**LEGAL ADVERTISEMENT
HISTORIC PRESERVATION BOARD
CITY OF PORTLAND
Public comments are taken at all meetings.**

**PUBLIC HEARING
71 INDIA STREET**

TO: Chair Benson and Members of the Historic Preservation Board
FROM: Deborah Andrews, Historic Preservation Program Manager
DATE: May 11, 2017
RE: May 17, 2017 **PUBLIC HEARING**

Application for: Certificate of Appropriateness for Building Addition
Address: 71 India Street, addition to existing Amato's store
Applicant: Dominic Reali Realty LLC.
Architect: Evan Carroll, Bild Architecture

CITY OF PORTLAND, MAINE
HISTORIC PRESERVATION BOARD

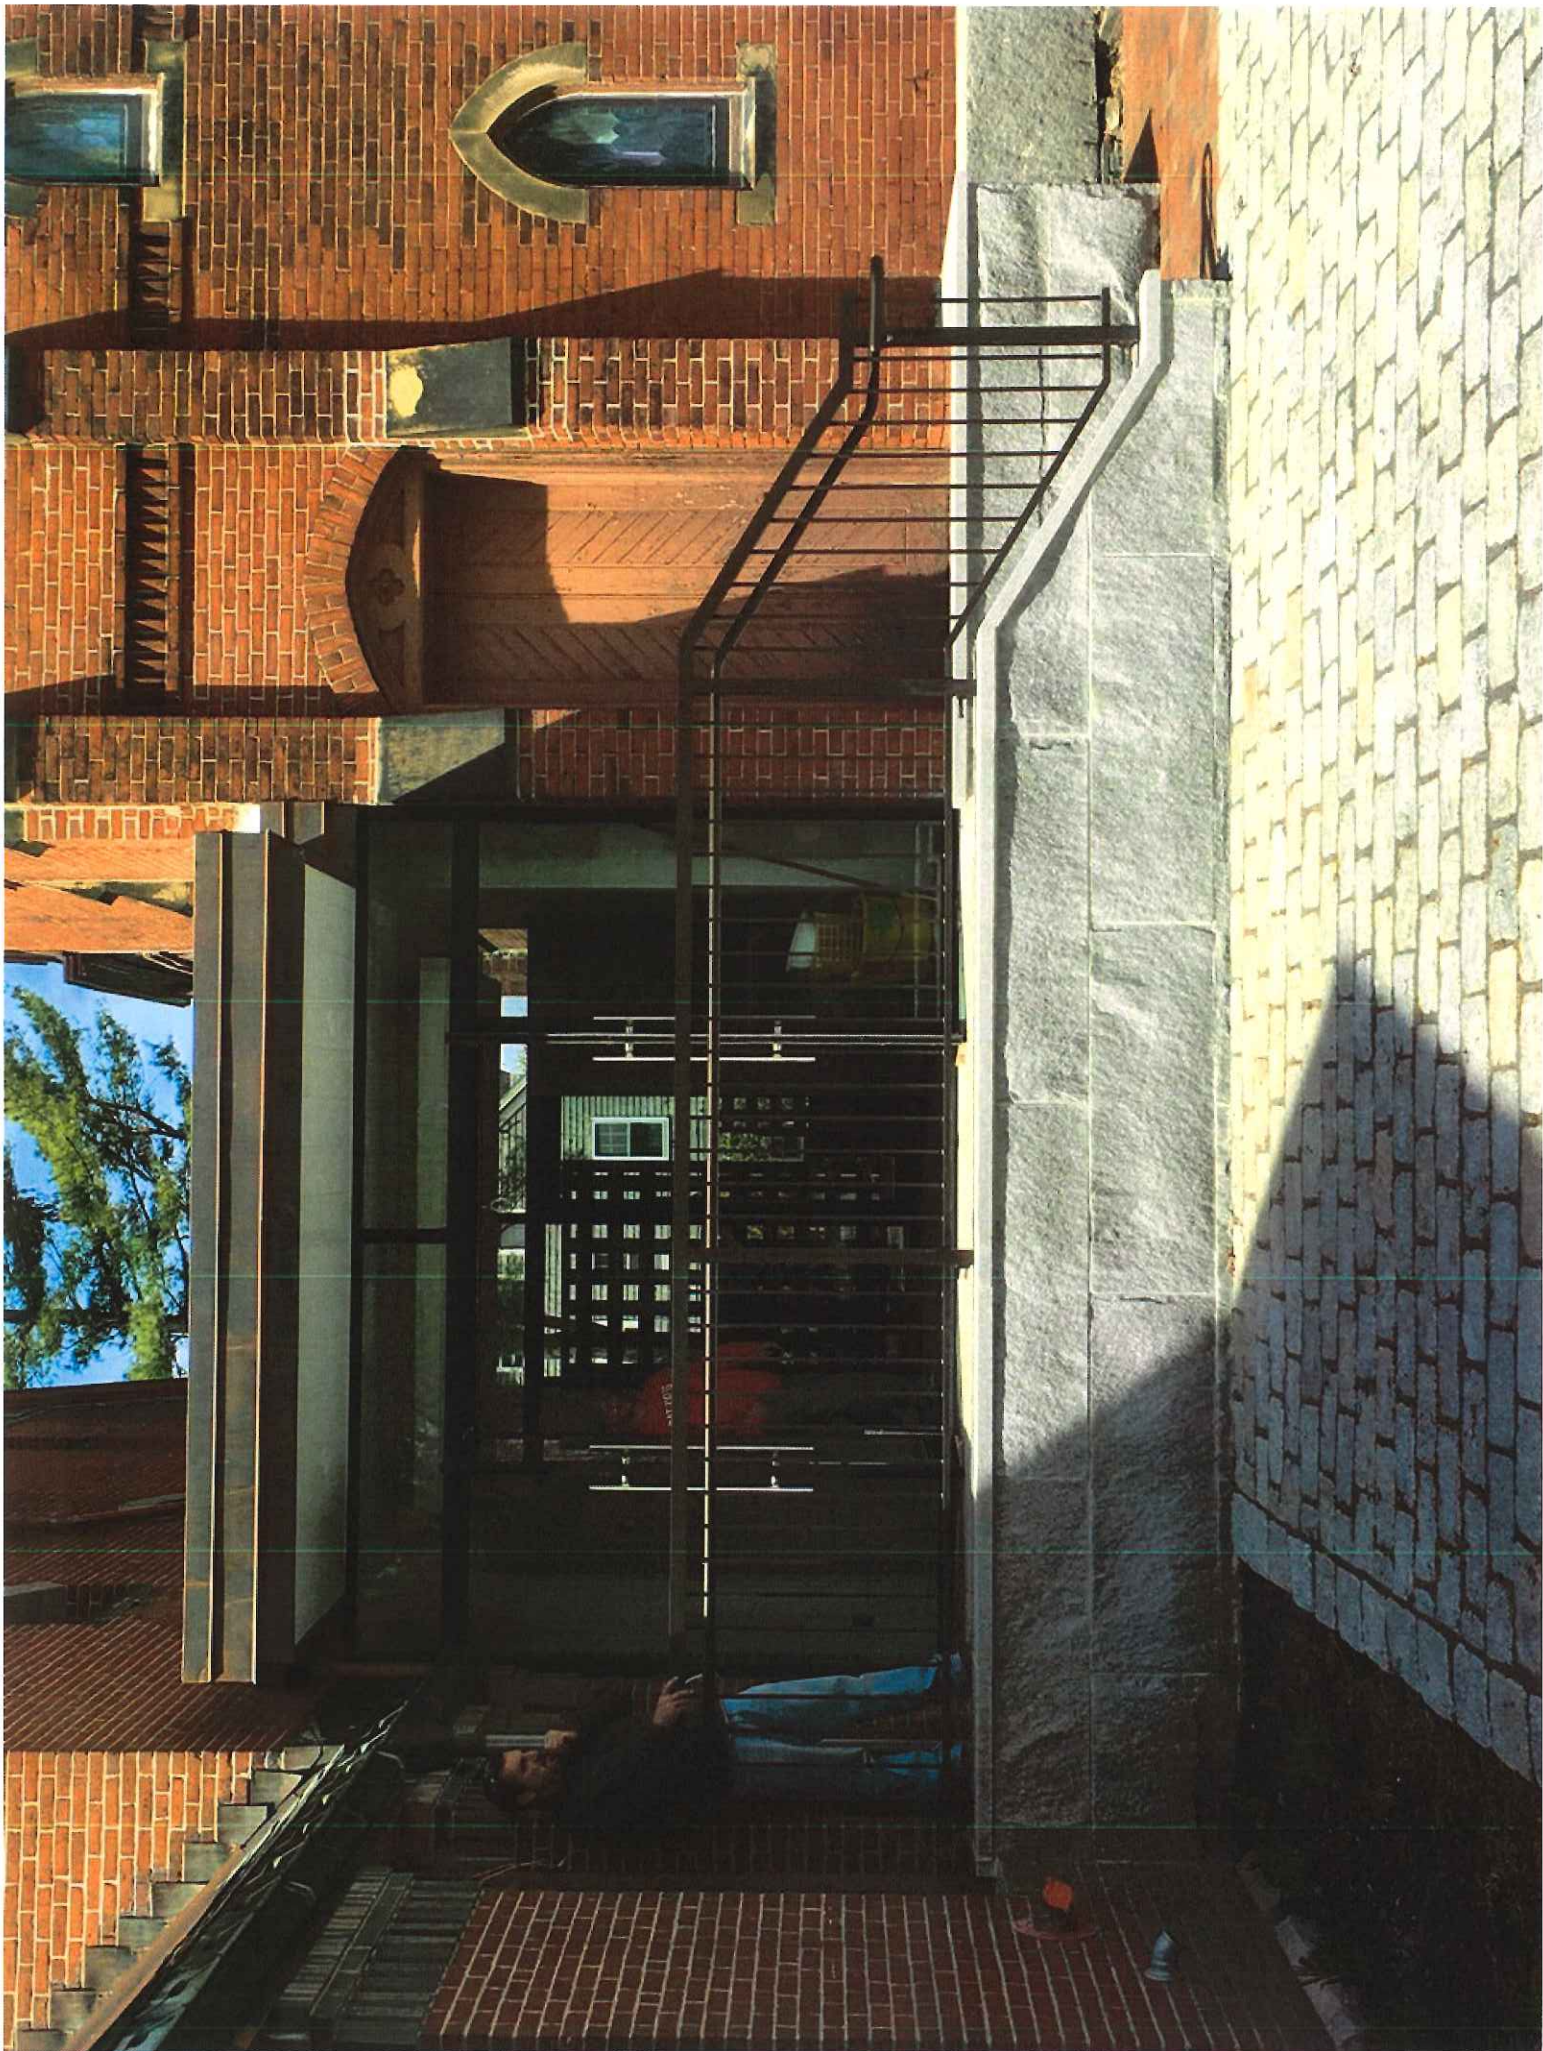
The revised railing was brought to the staff's attention by the contractor at the recommendation of the architect. When Mr. Winch was shown the railing by the general contractor in a site visit, he noted that it did not comply with the approved design and that he had not been provided a shop drawing for final sign-off prior to its fabrication. As built, the railing is 40 inches tall and all components of it feature square edges. The top rail, which was to be graspable in the original design, is squared off and is too high and too wide to meet code in terms of being graspable. To meet code requirements, the fabricator added a lower, graspable handrail inside the railing system at 34" above grade. The entire assembly is bronze anodized aluminum.

In his letter, Mr. Winch describes the circumstances that led to the deviation from the approved plans. The concerns described in the letter do not explain the change in the design itself (which now includes a transom) or the different hardware finish. The decision to change the entry system was made by the project team without advance notice or approval from city staff.

ATT. 4
EXCERPT FROM
11/18/15 APPROVED
PLANS

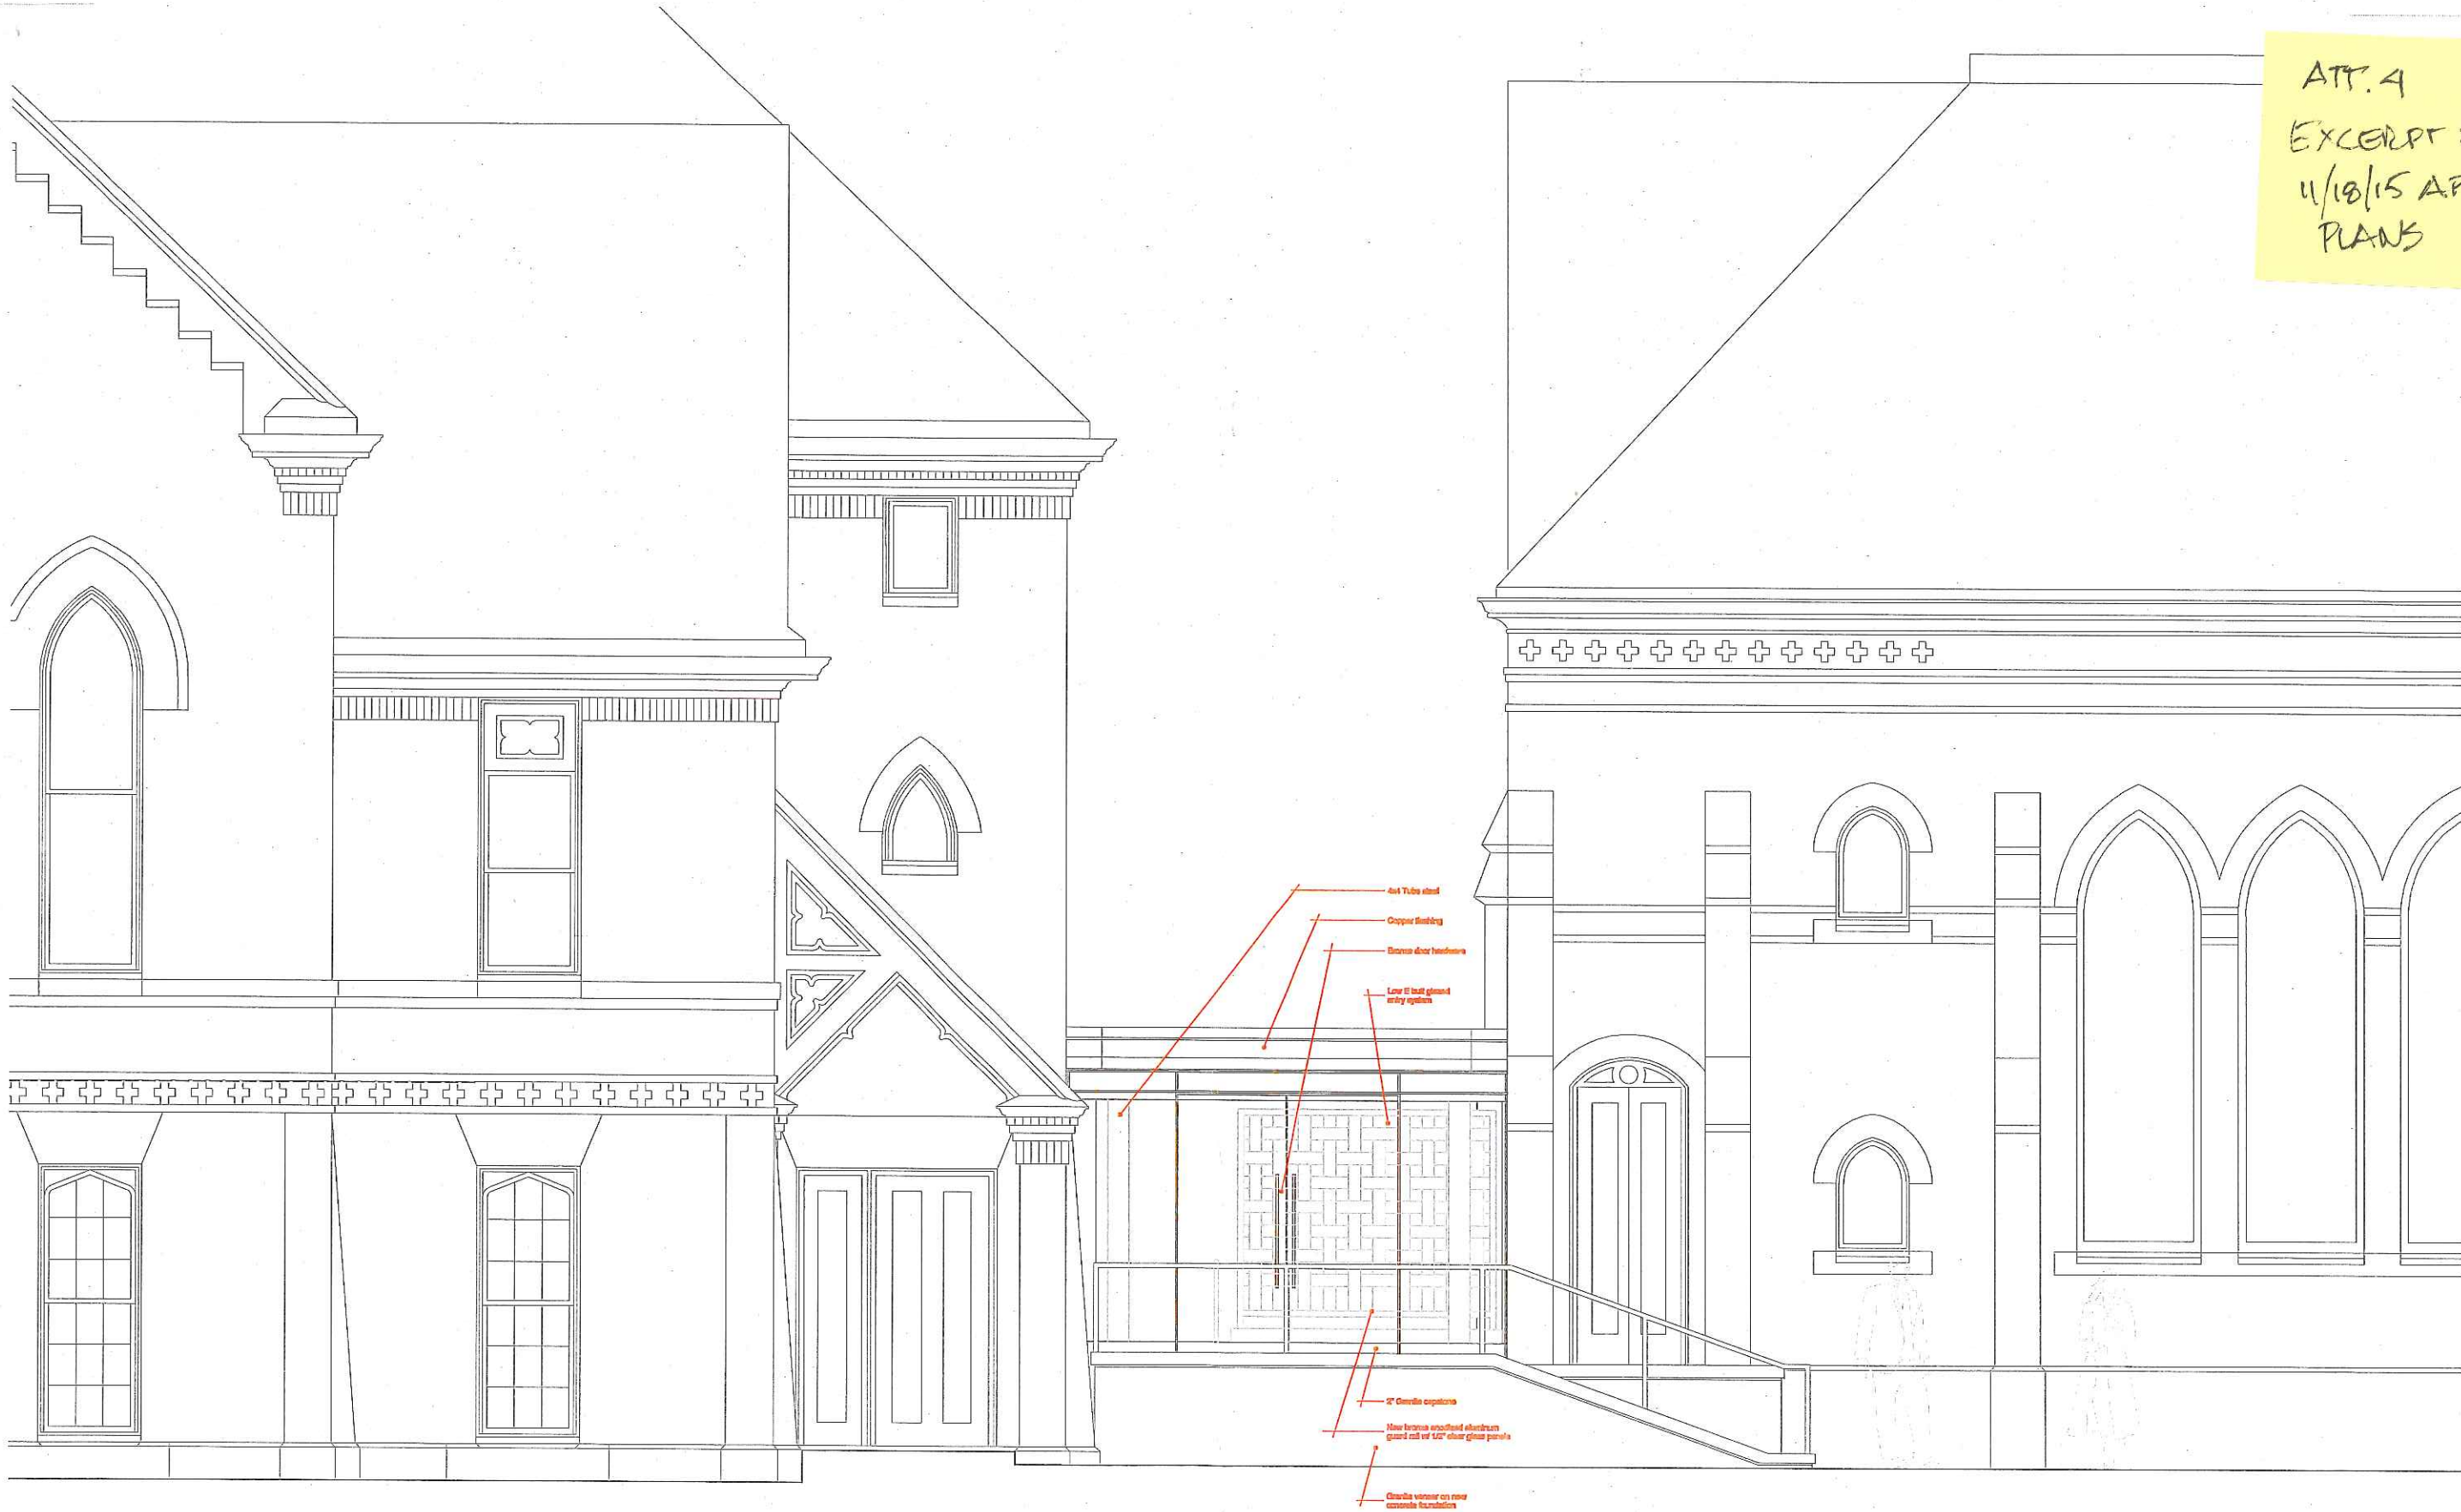
The architectural character of the connector was discussed at some length during the Board's original deliberations. The 11/18/15 staff report includes a summary of the Board's response to the proposed connector design when it was presented at the workshop preceding the public hearing:

With respect to the question of meeting code requirements, it should be noted that the original approved railing design—which called for a height of 34”, featured a single graspable handrail at the top and no handrail extension typical of ADA-design railings—was acceptable to code officials given the historic designation of the building.

ATT. 5
HANDRAIL PRESENTED
FOR CONSIDERATION
BY BOARD ON 4/15/16.
INCLUDED ON CONSENT
AGENDA.

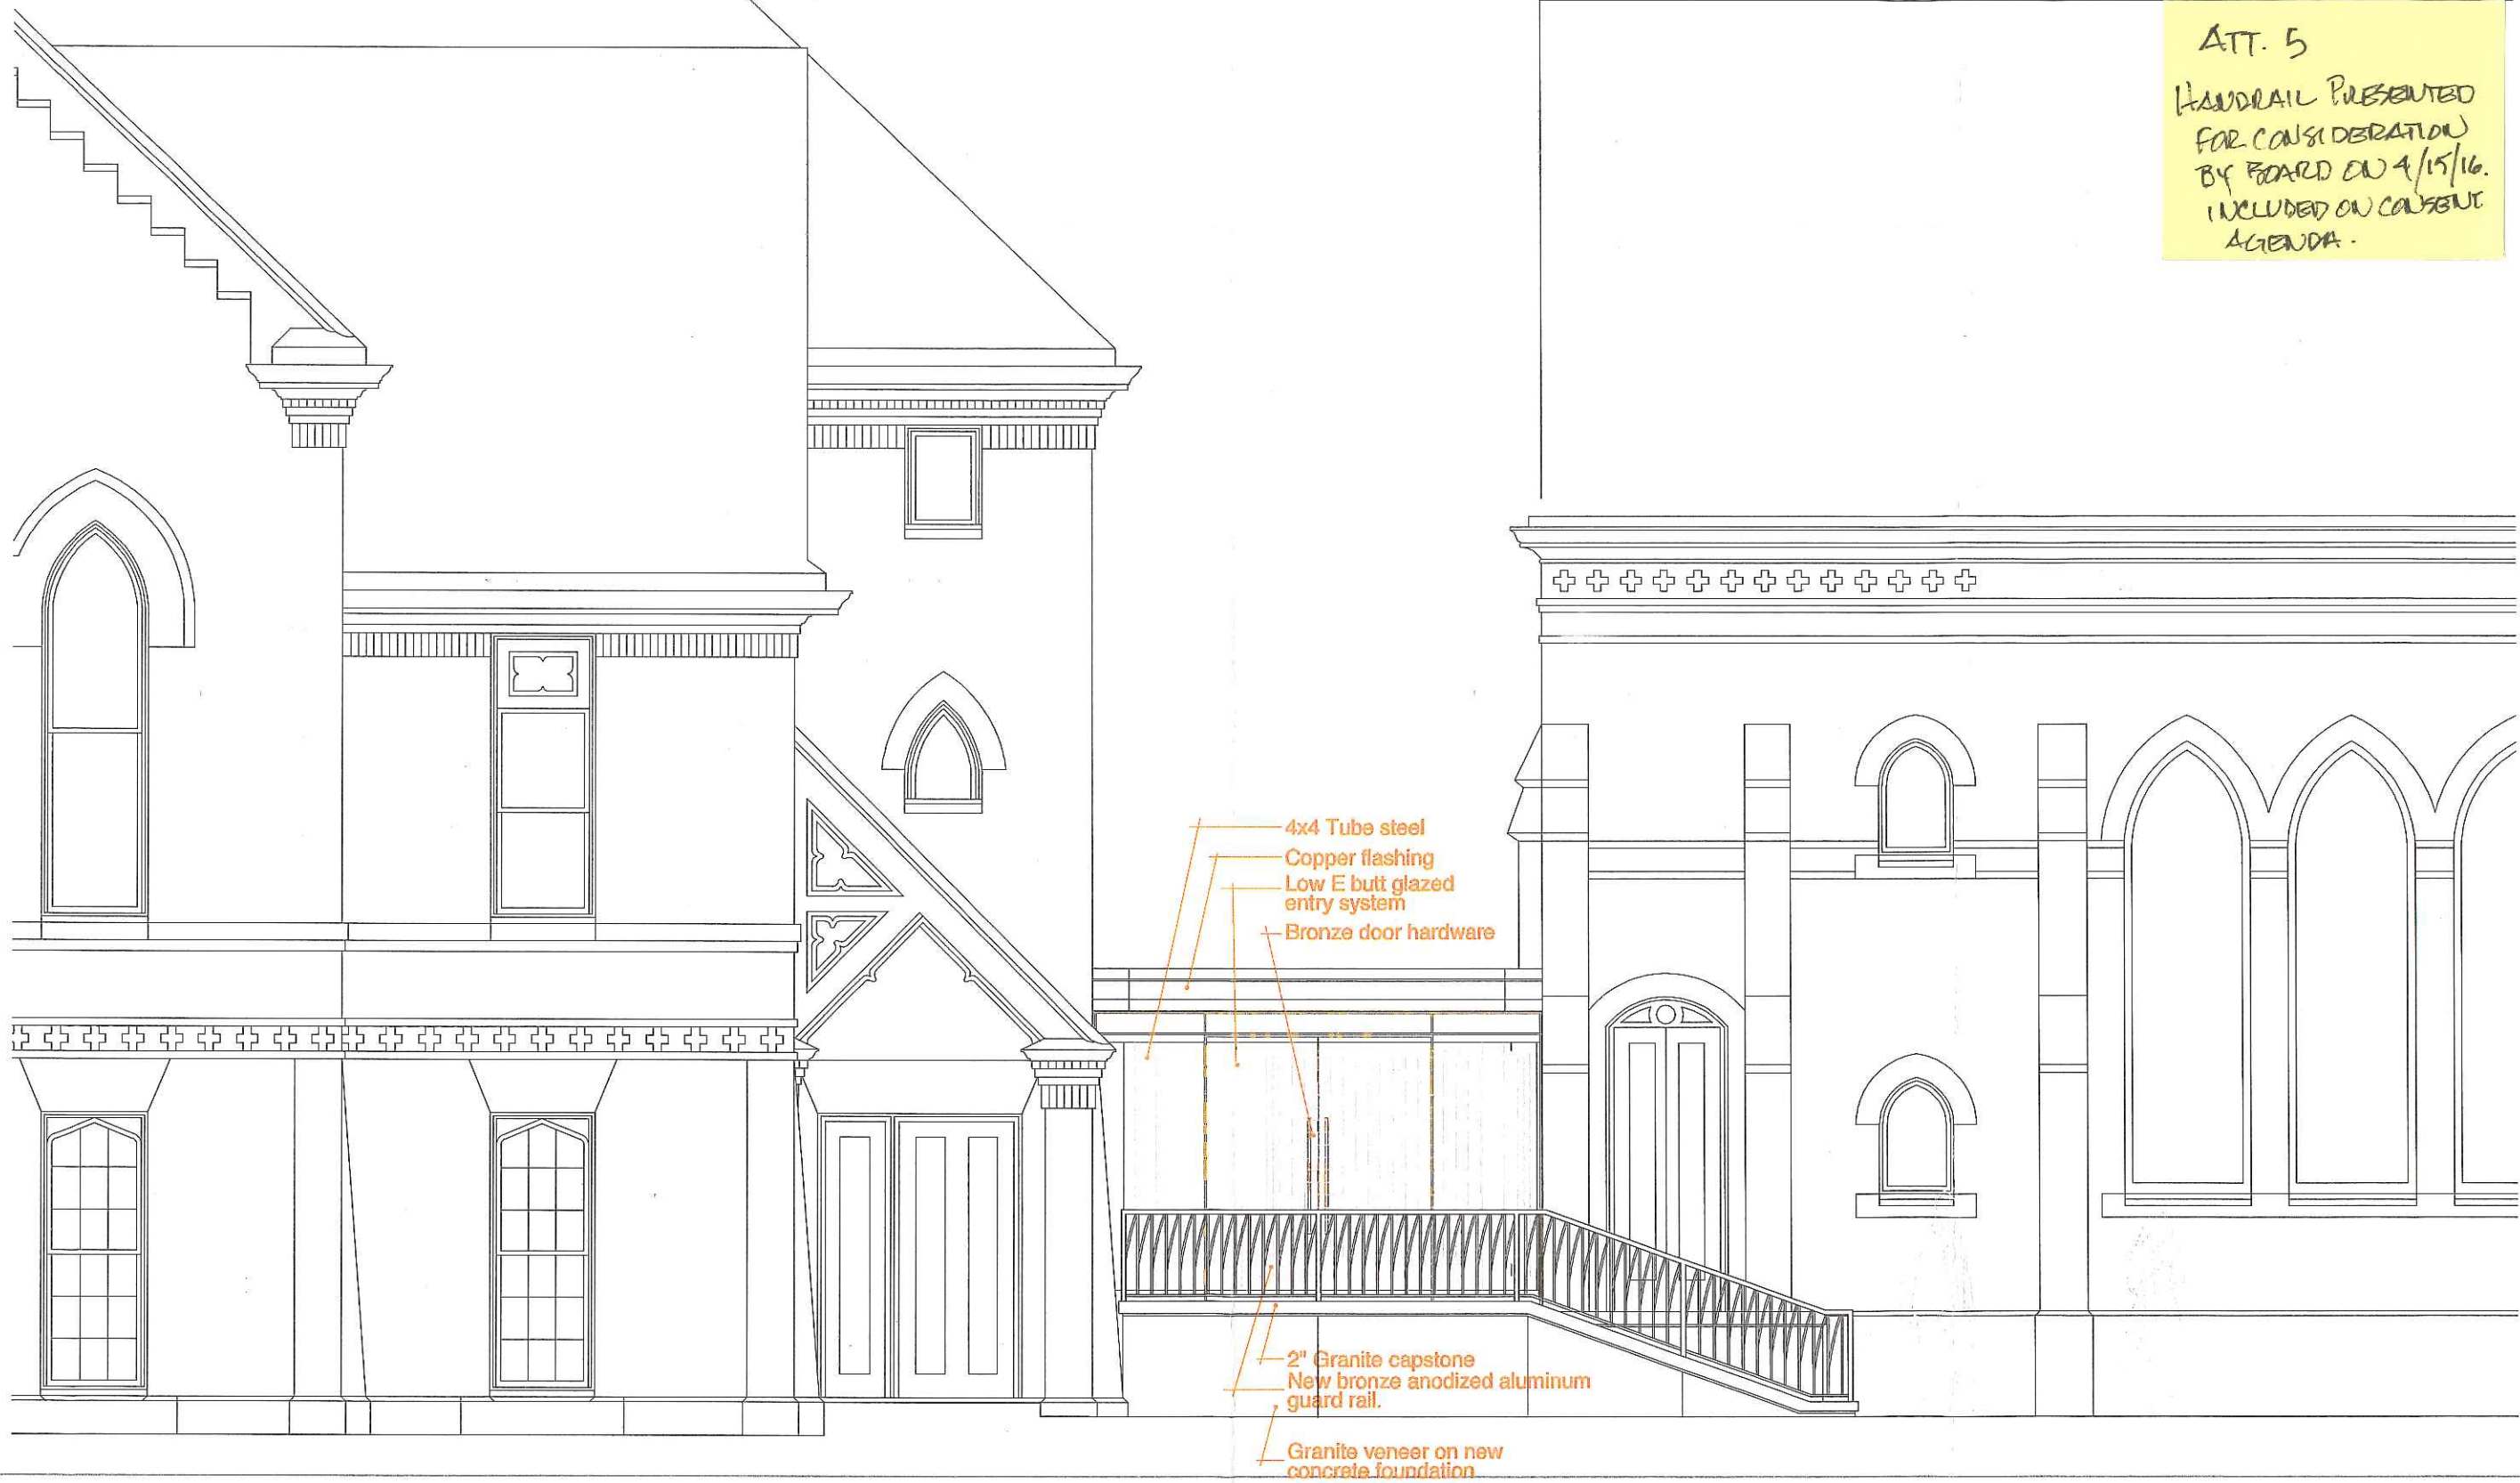
- Add separate walkway that runs from Thomas Street sidewalk to new connector. Walkway to run parallel to south elevation of church and then return toward connector. Planting bed to be provided immediately adjacent to south elevation of church.
- Expand depth of planting bed underneath stained glass windows at rear of paved courtyard.
- Add planting bed against north elevation of Parish Hall
- Final railing design to be reviewed and approved by staff. As per staff review, final railing design to feature simple straight black balusters with bronze rail.
